**DESIGN REVIEW COMMITTEE MEETING AGENDA**  
**Monday, April 30, 2018, 4:00 PM**  
**City Hall, 616 NE 4th Avenue**

**STAFF REPORT**  
**Design Review Application for Hetherwood Residential Development**  
**City File No. DR16-03**

**Revised STAFF REPORT AND DECISION FOR  
HETHERWOOD RESIDENTIAL DEVELOPMENT  
(FILE #SPRV16-03)  
SITE PLAN REVIEW & CRITICAL AREA REVIEW**

# Preliminary Site Plan for Hetherwood (ne. Kate's Woods)

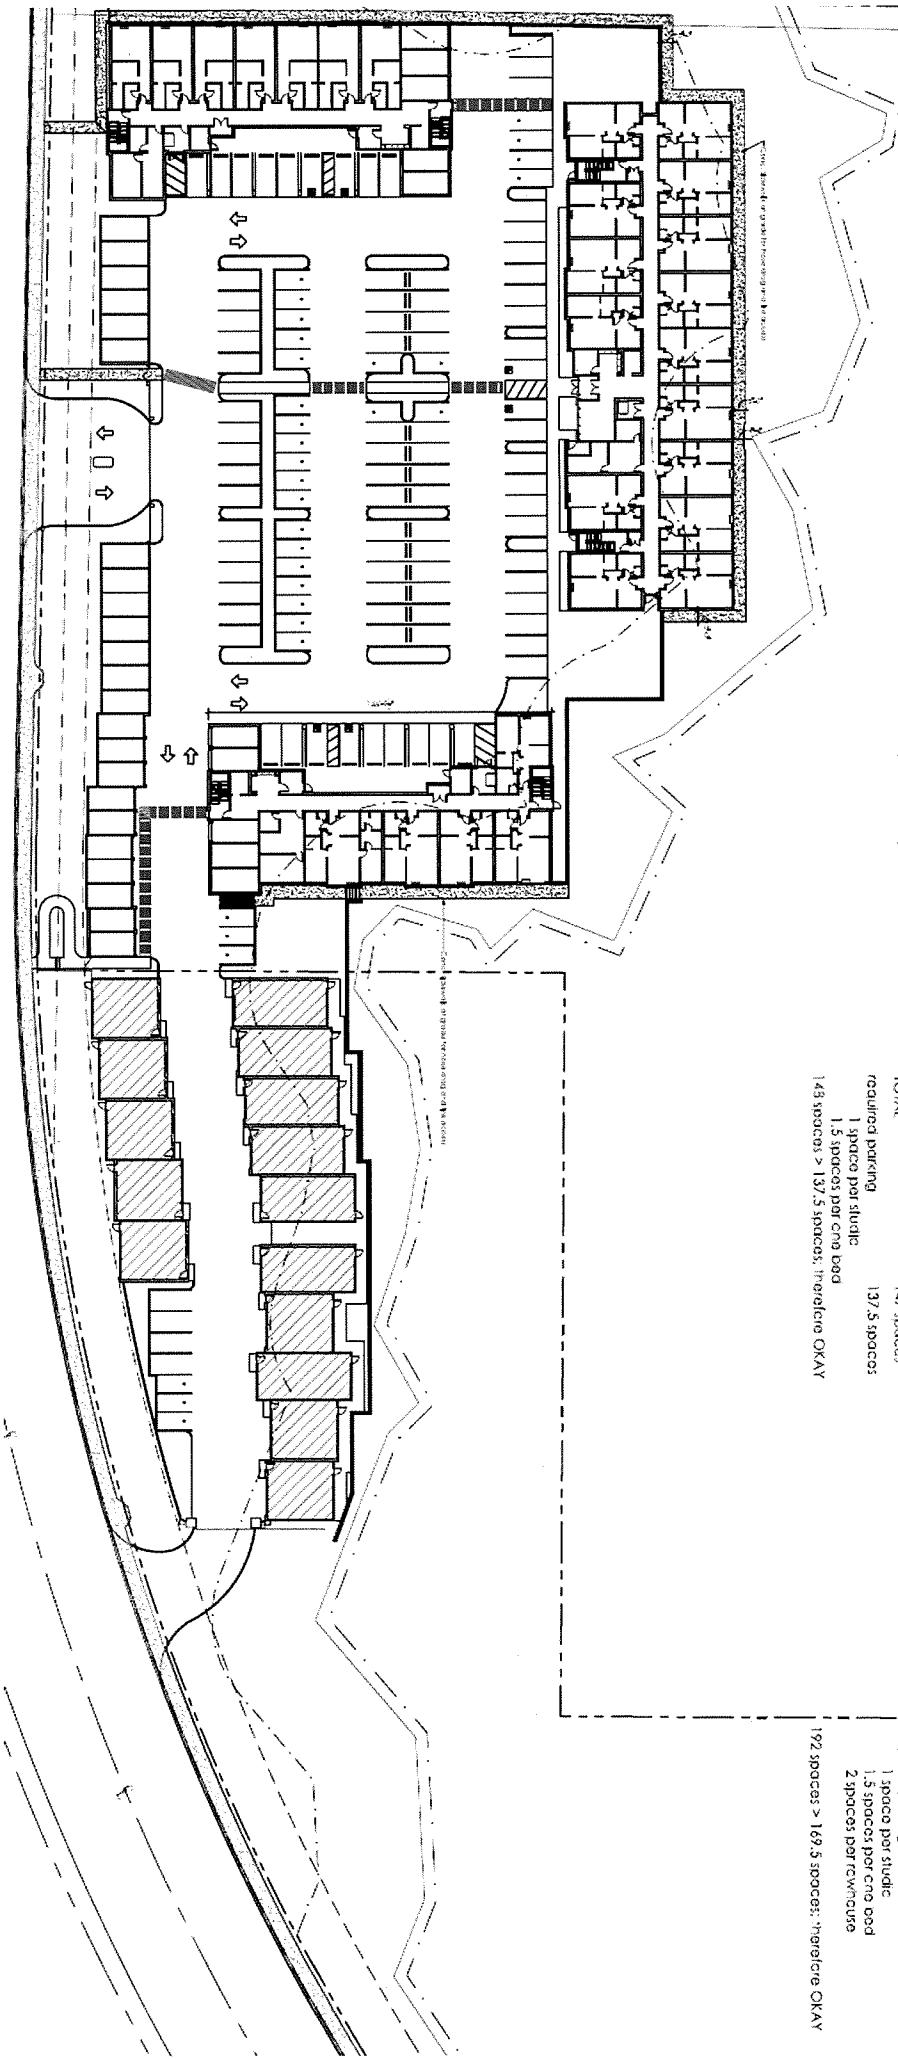
The easterly row house development (Phase 2) would be required to provide a minimum of one per unit or 16 parking spaces, per CMC§18.25.050. In contrast with the specific provisions in Chapter 18.25 Row Houses, there are provisions within "Residential Parking" at CMC§18.11.100, that states, "*Residential off-street parking space shall consist of a parking strip, driveway, garage or combination thereof.*" The design of the row houses includes garages at the first level, and a shared, seven space parking lot that is within walking distance of the units (less than 100-feet). The shared lot could be considered equivalent to either the "parking strip" or "driveway" requirement. Given that both garage parking and the shared lot are provided, off-street parking for the row houses is satisfied.

The westerly parcel (Phase 1) will have 134 units (127 studio apartments and 7 one-bedrooms) and will need to provide a minimum of **138 parking spaces**. The February 8<sup>th</sup> site plan drawing indicates that there will be 96 parking spaces within the open lot and 18 covered spaces for a total of **114 spaces**. The applicant has also proposed 33 spaces within the detached garage structures, and concluded that there would be a total of 147 parking spaces provided. However, the location of the garages appears to exceed the allowed distances to be counted toward parking for the multifamily use, as CMC§ 18.11.030 Location, requires that parking for multifamily dwellings be within 200-feet. The garages are located along the street frontage and the westerly garage (nearest corner), appears to be approximately 150 feet from the entrance of the West Apartments. The easterly garage appears to be over 220 feet from the East Apartment building. The North Apartment building is over 350-feet from either garage structure. It is possible that the West and East Apartments may have side entrances or exits that could shorten the distances to these garages, and open parking could be proposed in those locations instead. Without more details on the architectural layout, only the western garage with six (6) spaces meets the distance requirement. In summary, the property is short 18 parking spaces to meet the minimum parking requirements (Equation 138 – (114 +6) = 18). A shortage of parking on site, may produce a long term parking enforcement issue along NW Pacific Rim Blvd, where parking is not allowed. Per CMC§ 18.11.130 Standards, “The city shall have the authority to request a parking study when deemed necessary.” Given that parking is not allowed on the frontage road for residents, guests or overflow, and as defined in CMC, the location of the detached garages will not function as parking spaces, a parking study may be required.

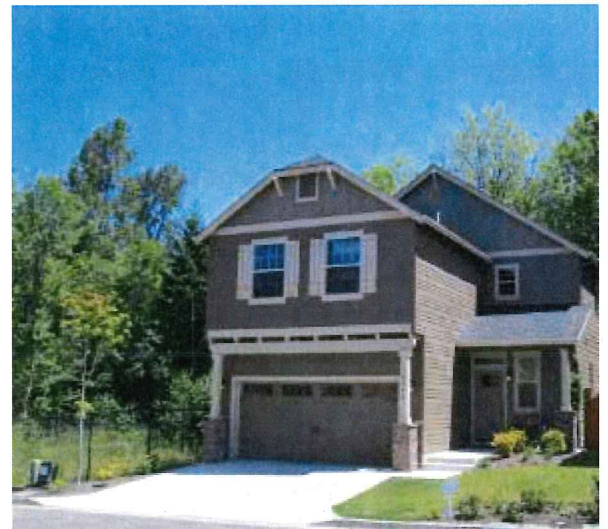
**[Building Height]** The applicant stated on page 1 of their narrative that if the code were modified to allow four-story residential structures, then they would like to apply for a “site modification”. As vested under the (then) MF-24 standards, residential developments were restricted to three stories. The city doesn’t have a “site modification” process as proposed by the applicant.

**FINDINGS FOR HEIGHT: Staff finds that four-story residential structures may be constructed, if unit count does not exceed 150 units consistent with the Settlement Agreement. Detached structures and other accessory structures must not exceed 14-feet.**
